Fwd: Mica White Quarries Mining Continuation Recommendations

From: Darin Duran <DDuran@cesareinc.com>
Date: January 11, 2022 at 4:46:35 PM MST
To: Bill Tezak <Bill@coloradoquarries.com>
Cc: Aaron Tezak <Aaron@coloradoquarries.com>
Subject: Mica White Quarries Mining Continuation Recommendations

Photo 1. View of Benches 1 (right) and 2 (left) on the northwest highwall.

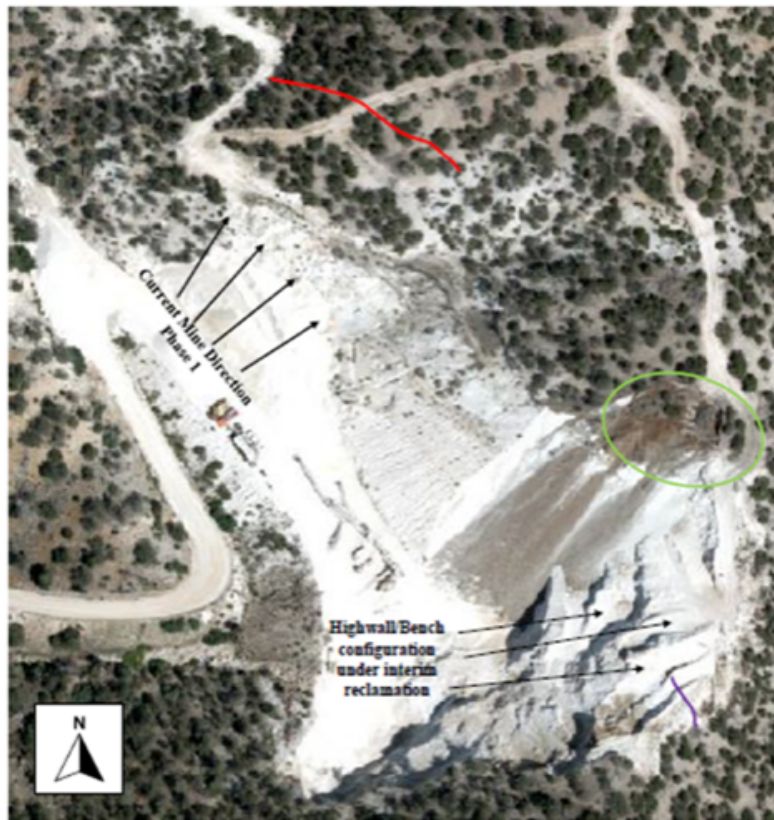
At your request, Cesare, Inc. (Cesare) visited the Mica White Quarry on December 21, 2021 to observe the condition of the slope in the area of current mining activity at the quarry. It is our understanding that during excavation of the northwest highwall, a crack form above the excavation face. The location of the northwest highwall (arrows) and the crack (red line) are shown below in Exhibit 1. It is also our understanding that the crack formed during excavation of Bench 2 of the northwest highwall (Photo 1).

The crack at the time of our visit did not show any signs of vertical displacement. The dip of the crack as observed in a cut face of an access road was about 75 degrees. We did not observe any signs of toe bulging in any of the benches in the northwest highwall. Cracking also occurred during mining of the NE/E highwall. The cracks in the NE/E highwall did not appear to extend to the cut face but terminated after 10's of feet (estimated as the area could not be safely accessed).

The cracking is likely associated with stress relief along predominant jointing orientation. The stress relief occurred during excavation of Bench 2. The likely instability will be toppling, where blocks rotate off the top, or high angle planar sliding. This is consistent with the description of the behavior of the NE/E highwall face. If this crack remains consistent in behavior, the risk of a large catastrophic failure of the northwest highwall is low.

Cesare recommends to conduct the excavation from the top down. The purpose is to reduce the driving forces in the slope. Additional excavation of Bench 2 into the slope should be avoided at this time as this can reduce the resisting forces. Blocks may topple or slide effecting individual benches, especially near the top. These blocks can cause debris to slide down to lower benches. The occurrence of these blocks should be monitored, especially above the upper bench. If the cracking increases in width or instability is noted, the unstable blocks can be scaled back. It is our understanding that the crack in the access road has been covered. The subgrade of the road should be monitored for the crack reappearing. If the crack reappears, then the stability should be re-evaluated.
